RIVERWOOD SUBDIVISION, PHASE THREE

APPLICATION NUMBER 10 DATE September 1, 2005
APPLICANT Riverwood Estates Subdivision, Phase Three
REQUEST Subdivision

DETAIL SITE PLAN

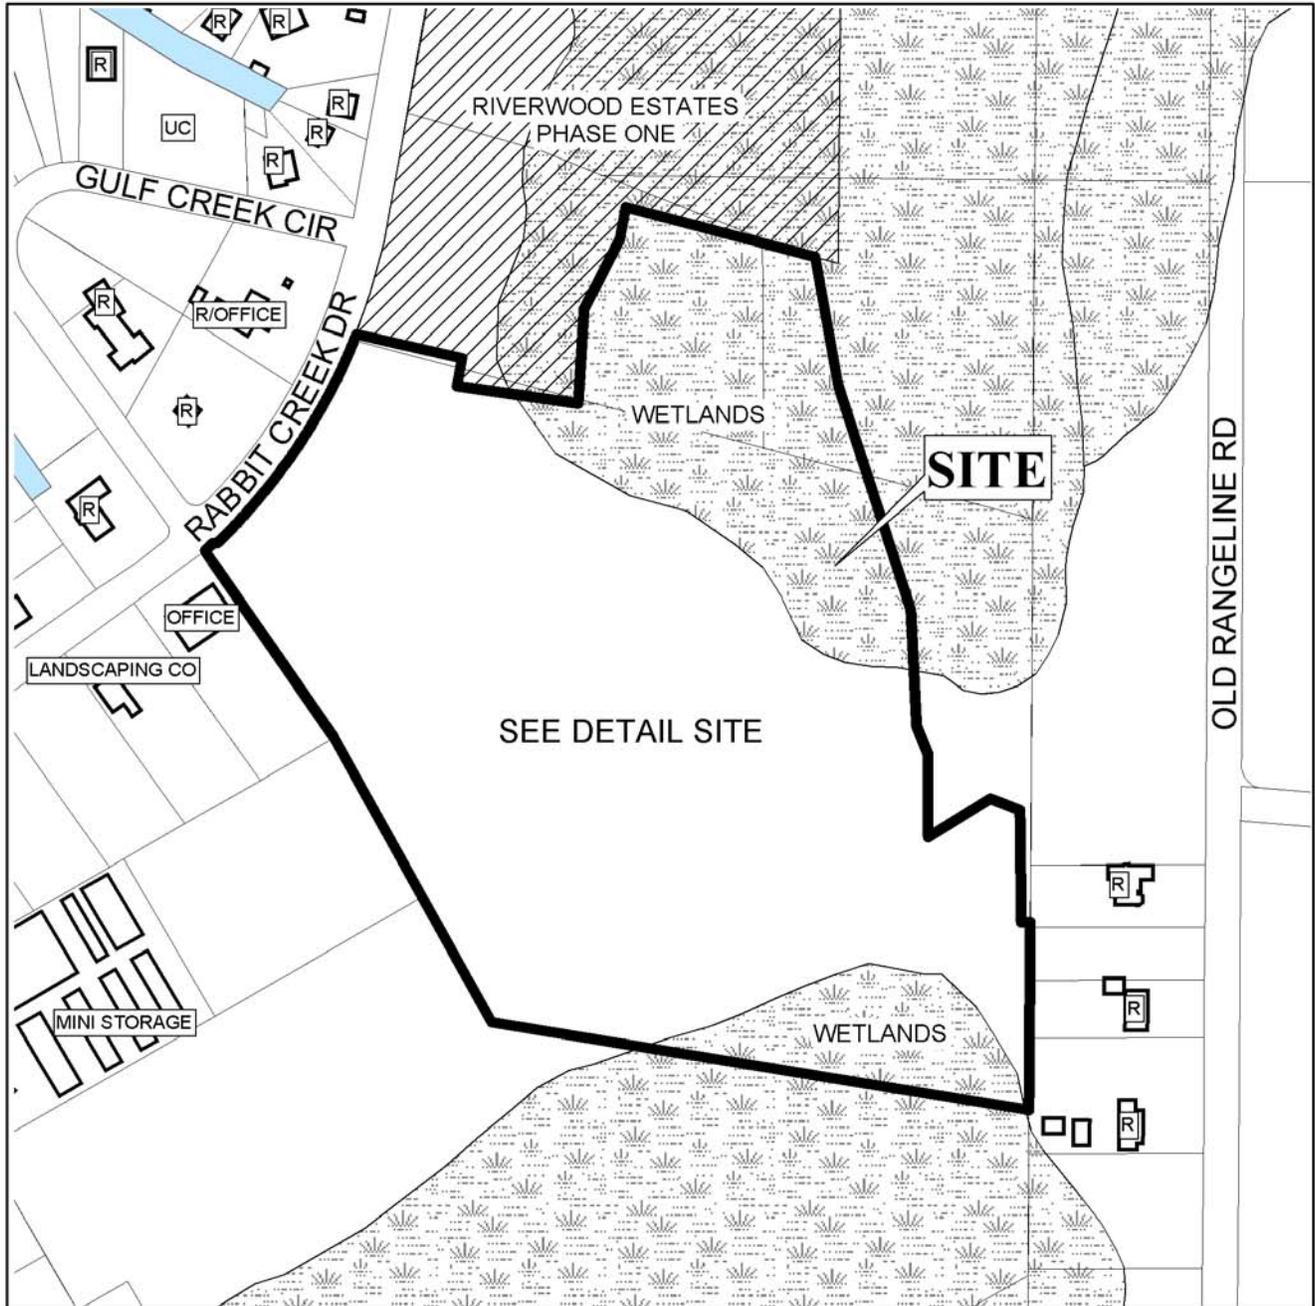
The site fronts Rabbit Creek Drive, a minor street which has a right-of-way width of 60 feet. Rabbit Creek Drive predominantly serves residential uses, therefore access from the site to Rabbit Creek Drive is a concern. As designed, however, the proposed Phase Three subdivision will have fewer lots than proposed in the 2004 application, and access to Rabbit Creek Drive will be via the Phase One portion of the overall development, which is currently under construction. Thus, no additional curb-cuts from this Phase onto Rabbit Creek Drive are anticipated, and the existing note on the preliminary plat stating that Lots 1-4 denied direct access to Rabbit Creek Drive should be retained for the Final Plat, if approved.

The site is within the drainage basin for Rabbit Creek, a tributary to Dog River. In addition to existing wetlands, a portion of the site appears to be located within floodplains associated with the Rabbit Creek. The presence of wetlands and floodplains on the site indicate that the area may be environmentally sensitive; therefore, the approval of all applicable federal, state and local agencies would be required prior to the issuance of any permits.

The plat is recommended for Tentative Approval subject to the following conditions: 1) placement of a note on the Final Plat stating that easements and common areas are to be maintained by the property owners association; 2) placement of a note on the Final Plat stating

that any lots which are developed commercially and adjoin residentially developed property shall provide a buffer in compliance with Section V.A.7. of the Subdivision Regulations; 3) placement of a note on the Final Plat stating that Lots 1 through 4 are denied direct access to Rabbit Creek Drive, and; 4) approval of all applicable federal, state and local agencies regarding the wetlands and floodplain issues prior to the issuance of any permits.
